November 2019

### New B-FormLok™ Embossments

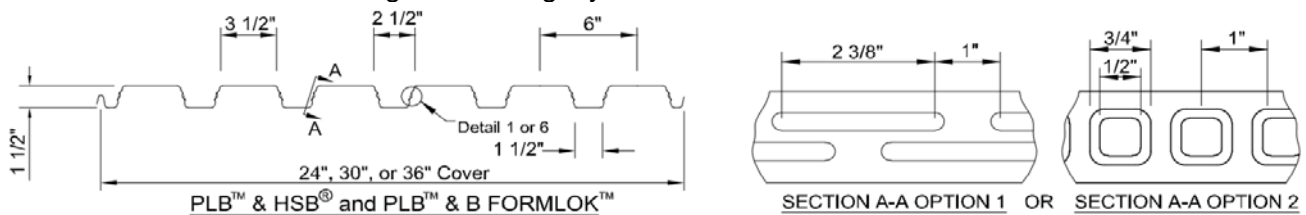
With the launch of Verco Decking's IAPMO ER-2018 there is a new embossment pattern for Verco's B-FormLok™ embossments. The old B-FormLok™ embossments shown in section A-A Option 1 of the IAPMO ER-0217 are not compatible with the IAPMO ER-2018 and the Verco web based design tools.

The new B-FormLok™ embossment pattern is also compatible with the values published in the IAPMO ER-0217 as shown below along with the legacy B-FormLok™ embossments.

As of January 01, 2020 Verco will no longer produce deck with the old B-deck embossments. The only exception will be ongoing project(s) designed to the IAPMO ER-0217 where Verco has already shipped deck with the old embossment pattern.
